Wiltshire Council Planning Consultation Response

URBAN DESIGN

Application No: PL/2026/01963

Site Address: Land South of Coate Road, Devizes

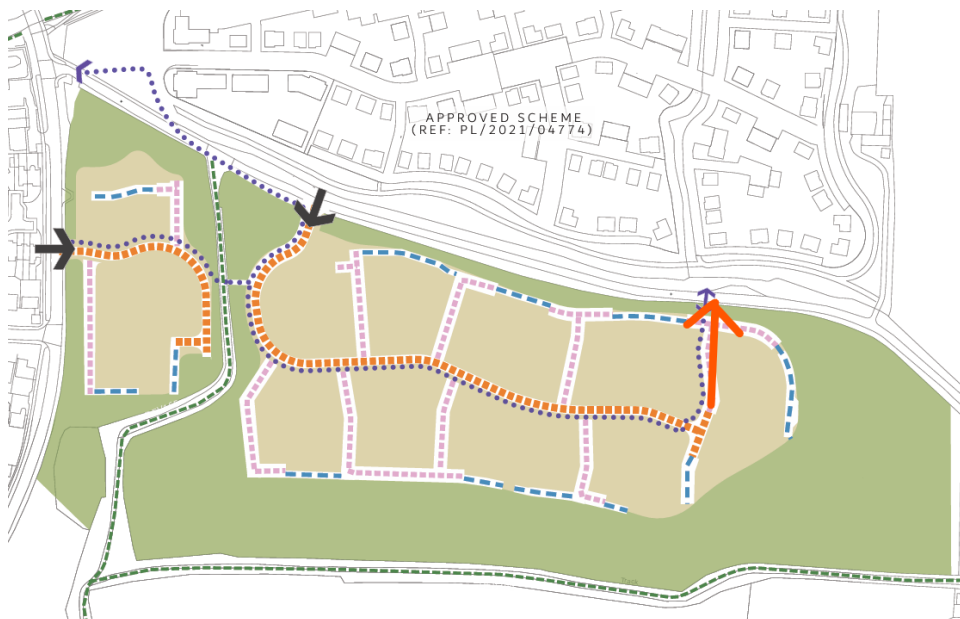
The site lies outside the Devizes settlement boundary (2020) and is not identified as a draft allocation in the emerging Wiltshire Council Local Plan (January 2023). It should therefore be considered a speculative site. At this early stage no detail or specific house designs have been submitted and my observations are therefore related to the layout in outline.

- 1) The proposed layout is overly reliant on cul-de-sacs, creating dead ends where turning heads and far ends are not visible from the junction with Coate Road. This is contrary to the Wiltshire Design Guide (WDG 5.1.8), which states that cul-de-sacs should be short and have their far end visible from a through-road junction.

This approach would also conflict with Core Policy 57 (vii) and (ix), as it would undermine legibility and accessibility. The reliance on vehicle reversing and turning at the ends of cul-de-sacs to serve dwellings and refuse vehicles, together with the proliferation of communal bin collection points, has the potential to create avoidable inconvenience for residents. Such an arrangement aligns with *Building for a Healthy Life* examples of “what red looks like” (pp. 18–19), rather than the preferred “what green looks like” (pp. 16–17), which advocates well-connected streets at the edges of developments. The cul-de-sac-led structure also undermines the ability of the proposed street network to function as a clear and legible hierarchy, as primary and secondary routes frequently terminate rather than forming connected through-routes.

To comply with the WDG and Core Policy 57, the main route should reconnect back to Coate Road, removing the long cul-de-sac and improving legibility and permeability. Please see screenshot below. If this is not feasible then an internal loop should be formed.
